PROPOSED CHANGES TO CROWMARSH COTTAGE, PE12 8ES.

NOTES: NORTH - EAST ELEVATION.

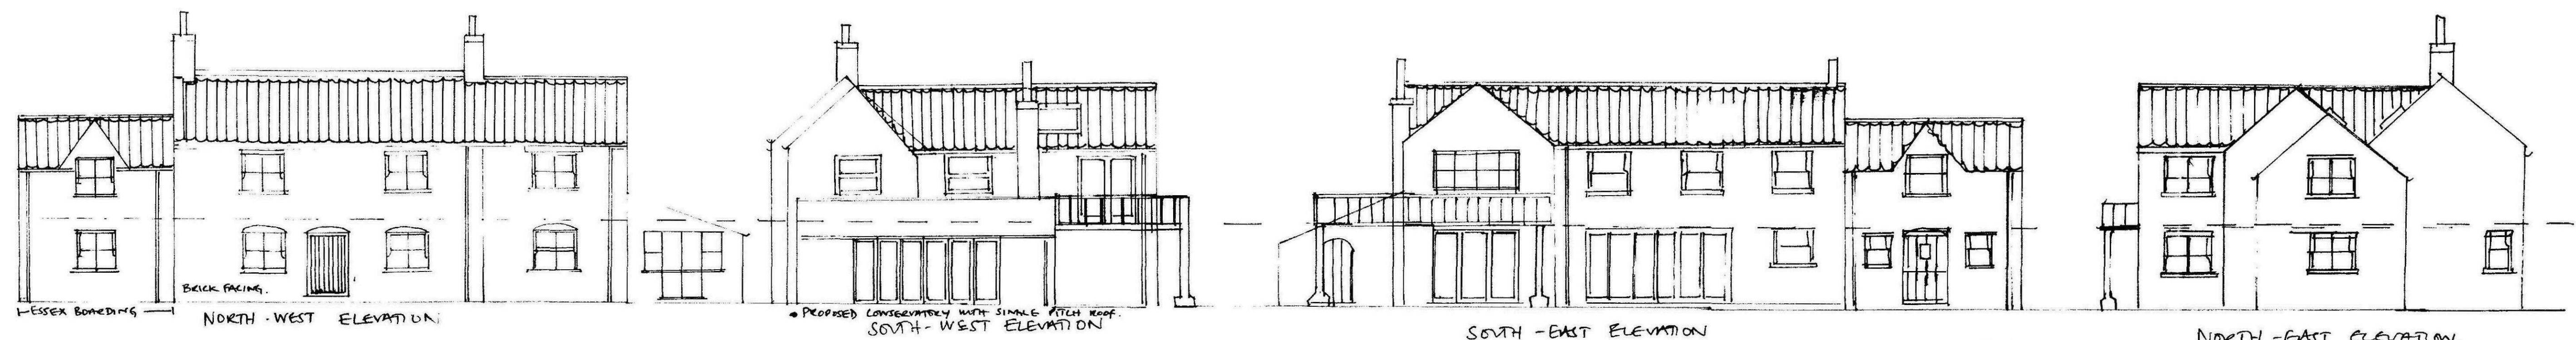
- Essex boarding to replace render on original plan. Natural wood color.
- Proposed double storey, vaulted ceiling with velux windows to replace single storey.
- Proposed conservatory set back 450mm from the evening room.

- Window in master bed enlarged to line up with triple sliding doors below (replacing french windows).
- Triple sliding, folding doors (2400mm) to replace french windows in original plan.
- Folding, sliding doors 4200mm to replace french windows in original plan.
- Bedroom 4 & 5 & bathroom windows realigned to line up with doors below.
- Proposed extension to single storey as in North-West Elevation.

- Location of 2 velux windows - 1 to provide light for ensuite to beds 2+3. - 1 to provide exit to valley for maintenance.

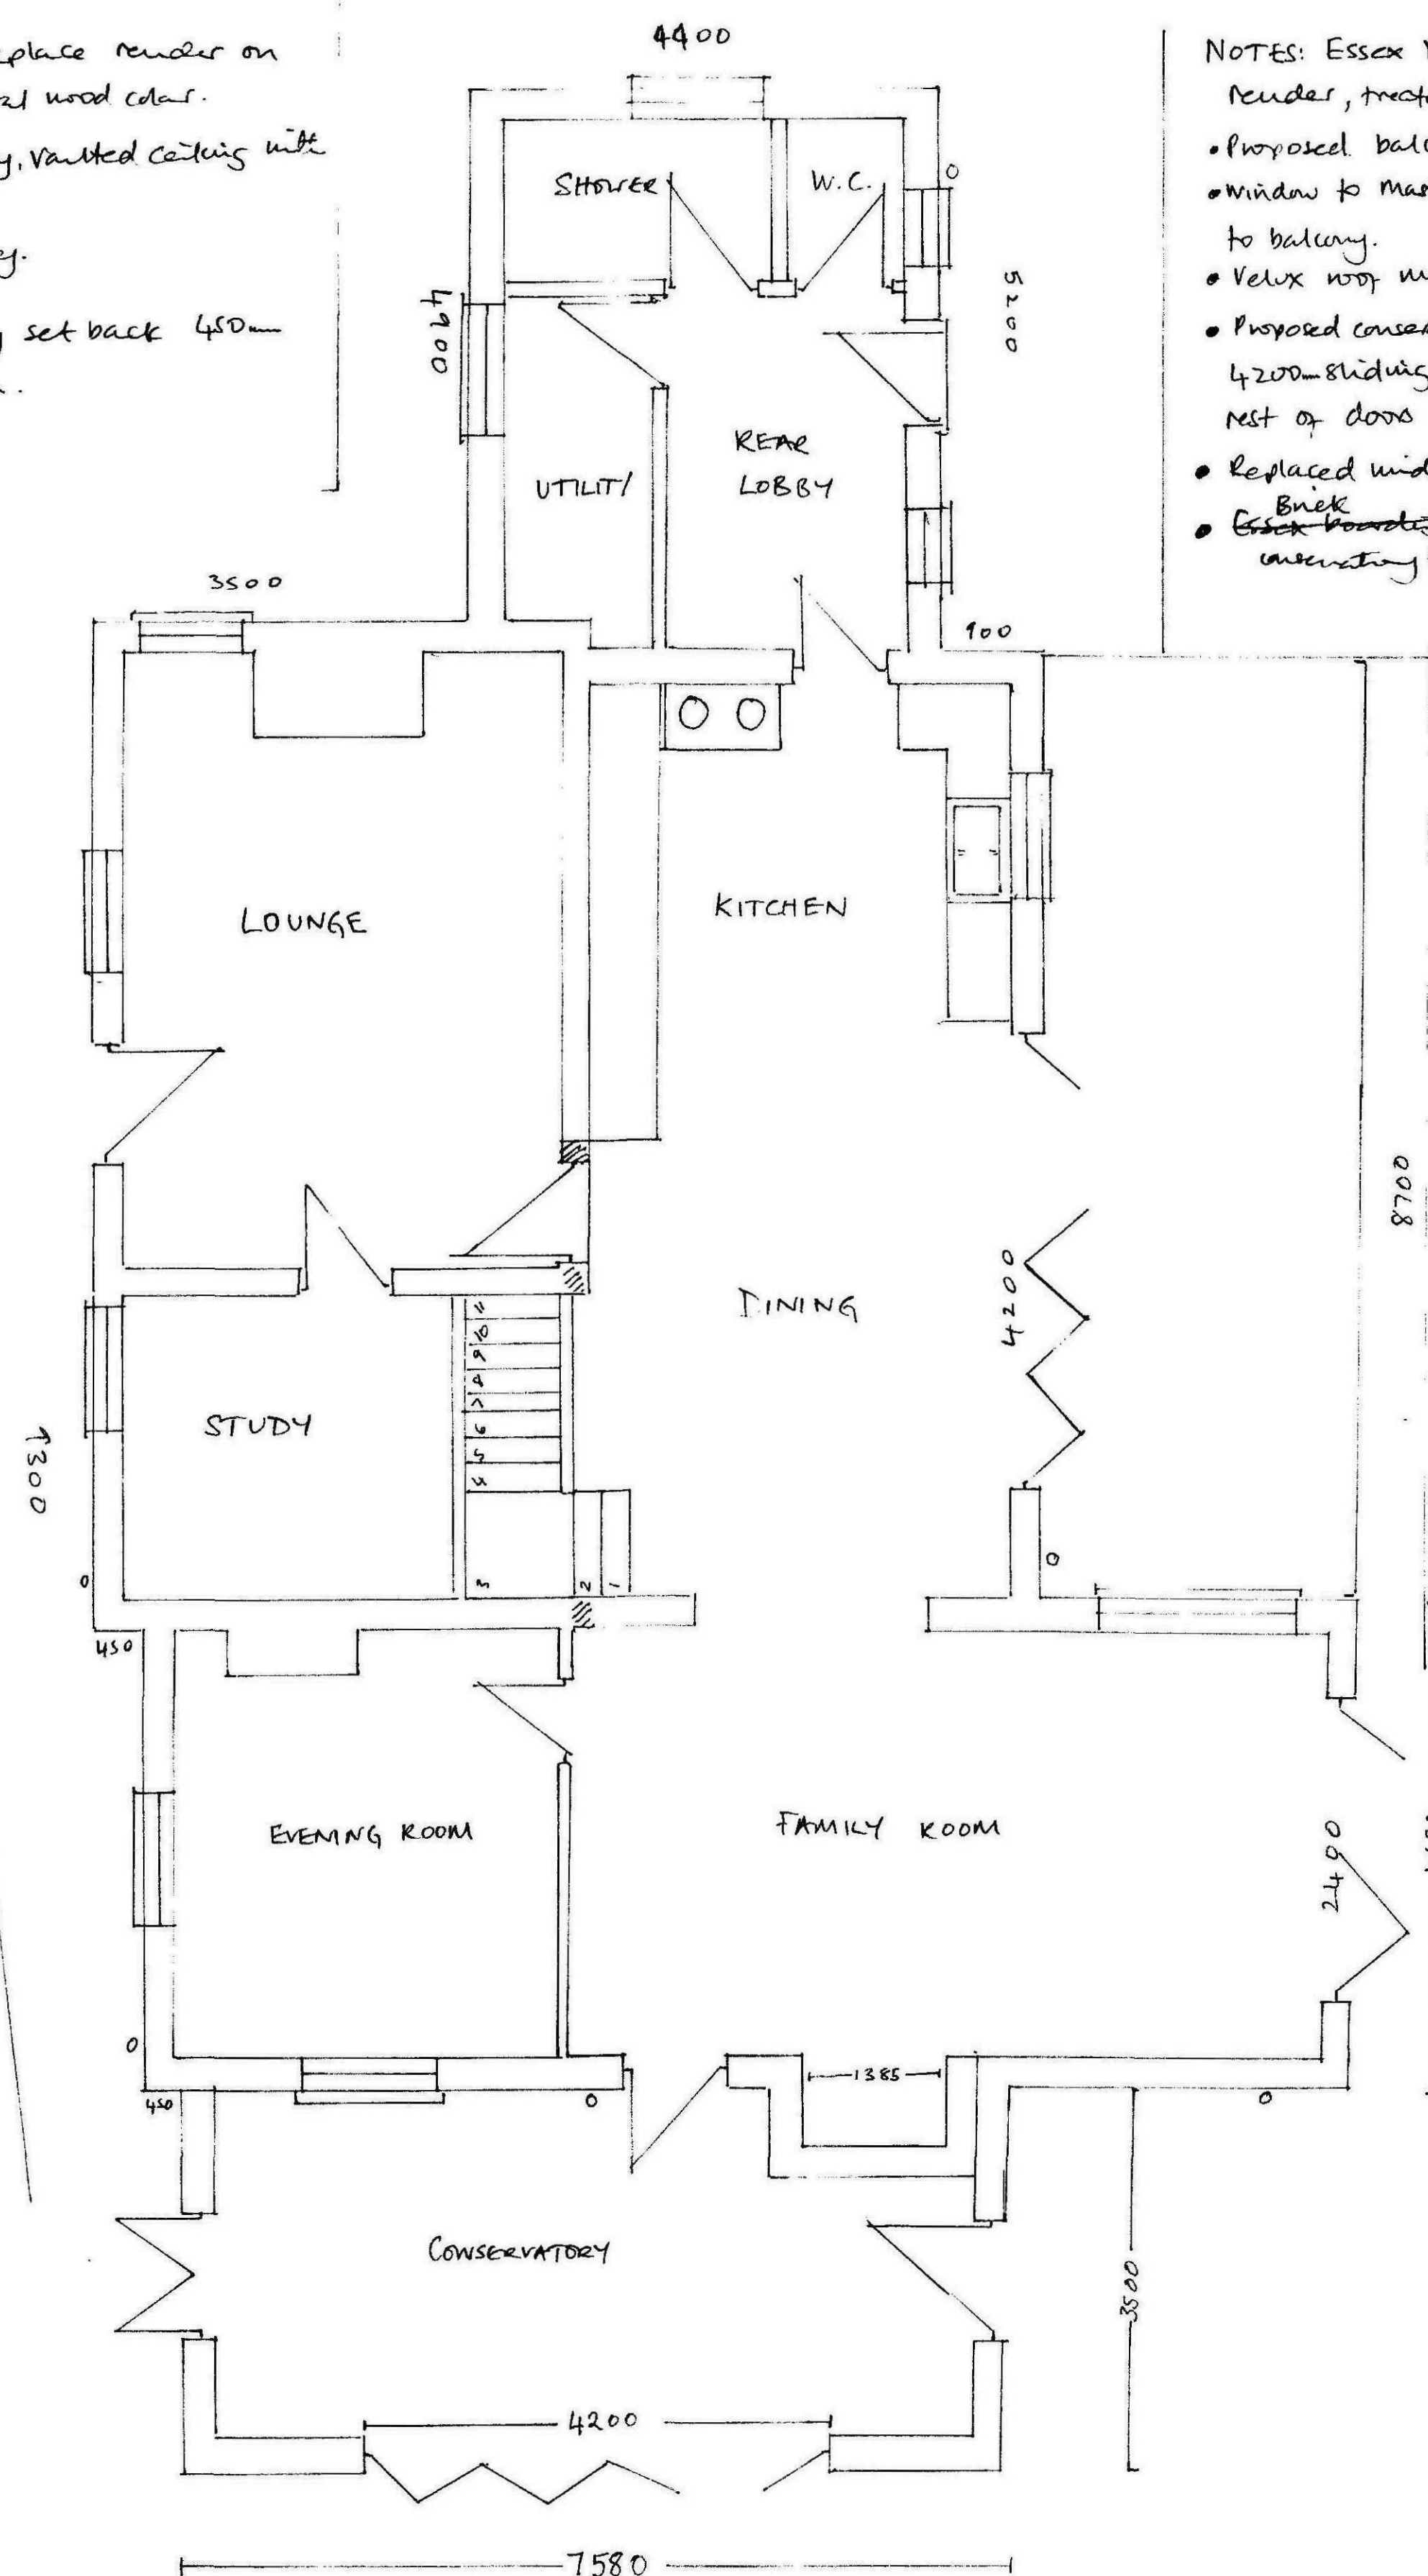
- NOTES: Essex boarding to replace all proposed render, treated remaining natural wood color.
- Proposed balcony to master bed, timber supports & balustrade.
 - Window to master bed replaced by French doors 1800, to balcony.
 - Velux roof windows to master bed.
 - Proposed conservatory with single pitch roof with 4200mm sliding, folding doors to match rest of doors in dining room & family room.
 - Replaced window to match existing.
 - Essex boarding to the exterior of the proposed conservatory to match house.

NOTES: Balcony from Master bed.
